Village of Arlington Heights
Plan Commission
Board Room
Arlington Heights Village Hall
33 S. Arlington Heights Road
Arlington Heights, IL 60005
May 13, 2015
7:30 PM

- A. Christina Court Subdivision - 1306/1310 E. Olive St. - PC#15-001
Preliminary Plat of Subdivision
- B. T-Mobile - 1000 S. Arlington Heights Rd. - PC#15-003
Special Use Permit for Wireless Antenna Tower

To: Plan Commission
Prepared By: Latika Bhide, Development Planner
Meeting Date: May 13, 2015
Date Prepared: May 7, 2015
Project Title: Christina Court Subdivision
Address: 1306 and 1310 E. Olive Street

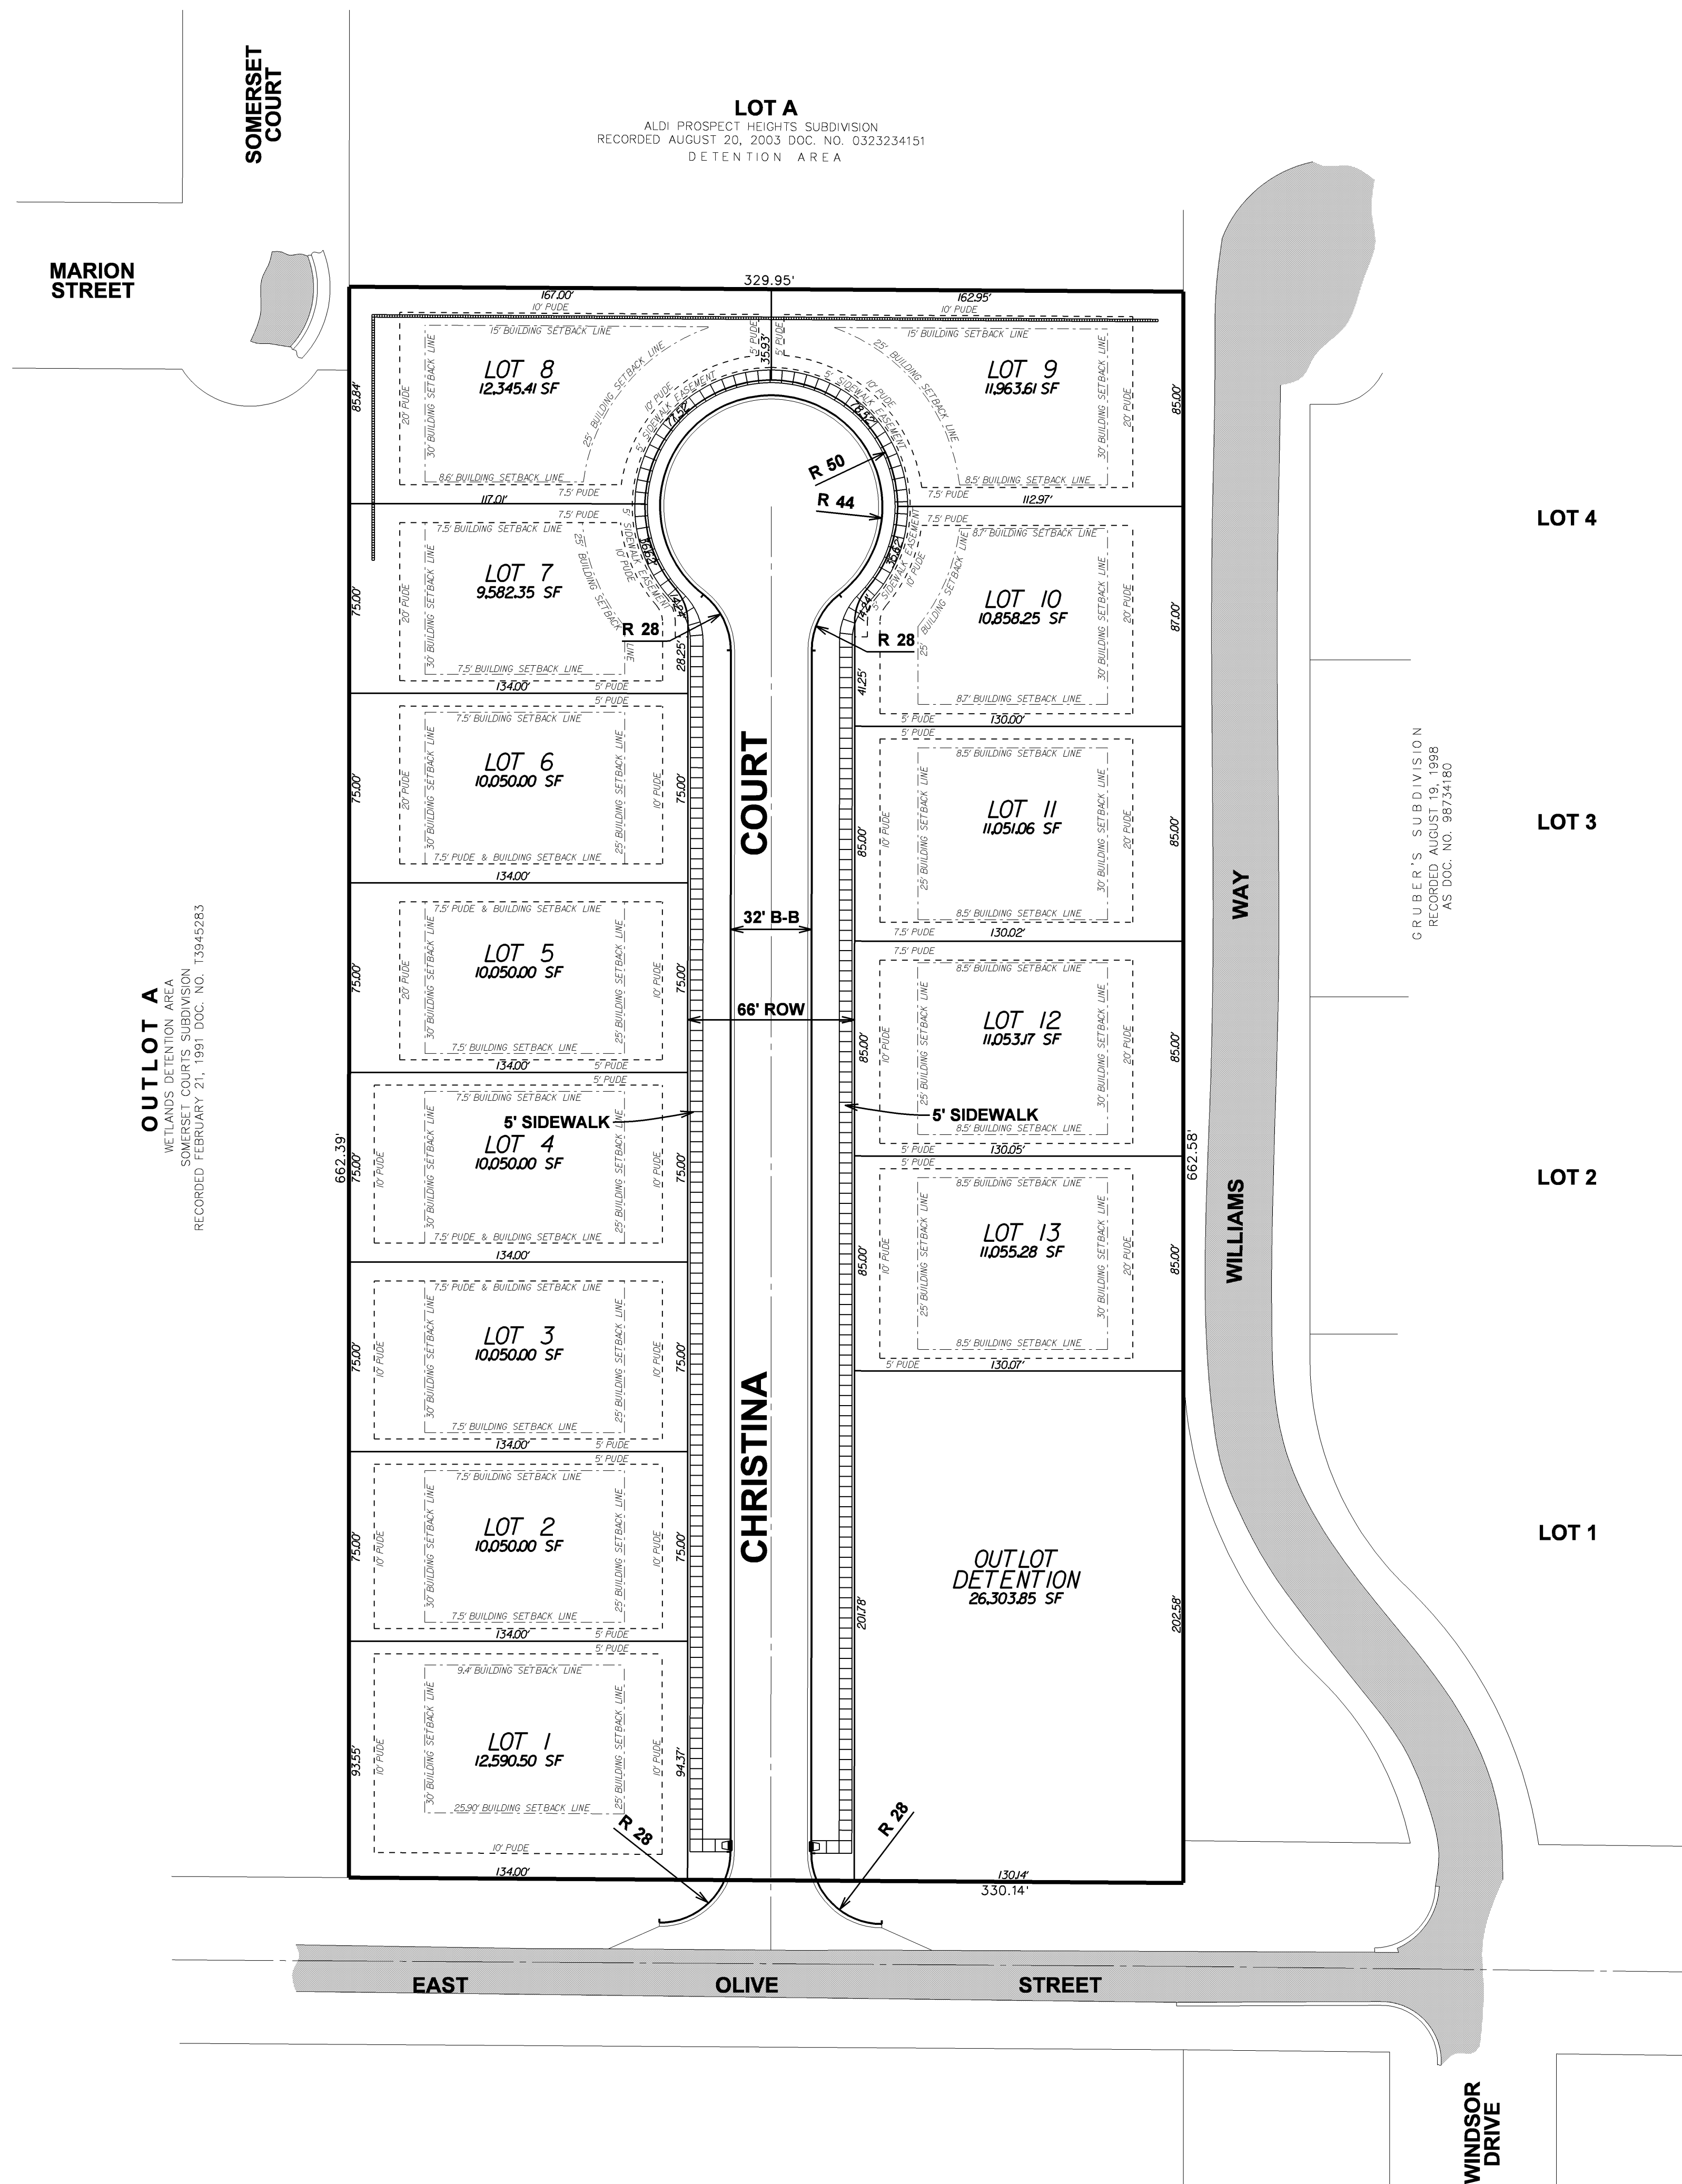
1. The site plan indicates a cul-de-sac with a curb diameter of 80 feet. Per the 2009 International Fire Code, Appendix D, Figure D103.1, the cul-de-sac diameter shall be a minimum of 96 feet. Also the entrance radius of the cul-de-sac shall be 28 feet as opposed to 25 feet.

Comment: The site plan indicates a cul-de-sac with a curb diameter of 80 feet. Per the 2009 International Fire Code, Appendix D, Figure D103.1, the cul-de-sac diameter shall be a minimum of 96 feet. Also the entrance radius of the cul-de-sac shall be 28 feet as opposed to 25 feet.

The local amendment to the 2009 International Fire Code, Appendix D deletes all dead-end road turnarounds with exception of the 96' diameter cul-de-sac. Refer to Figure D103.1. Relief from this code section may be accomplished through presentation to, with review and recommendation by the Village Building Code Review Board.

66' R.O.W.

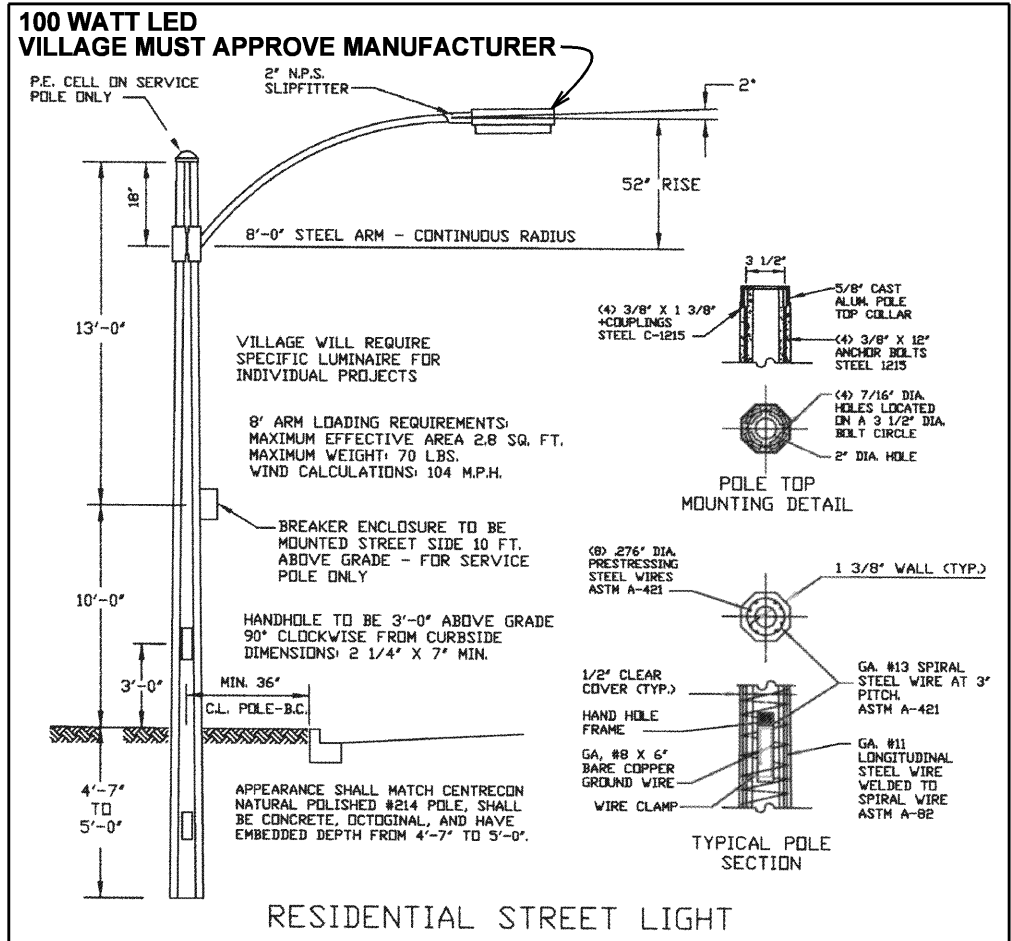
- A variation from Section 29-307 f Residential Lot Standards to allow double frontage lots.
- A variation from Section 29-304, Street Layout & Design from the requirement to provide a 66-foot right-of-way for a local street to allow 60-feet.
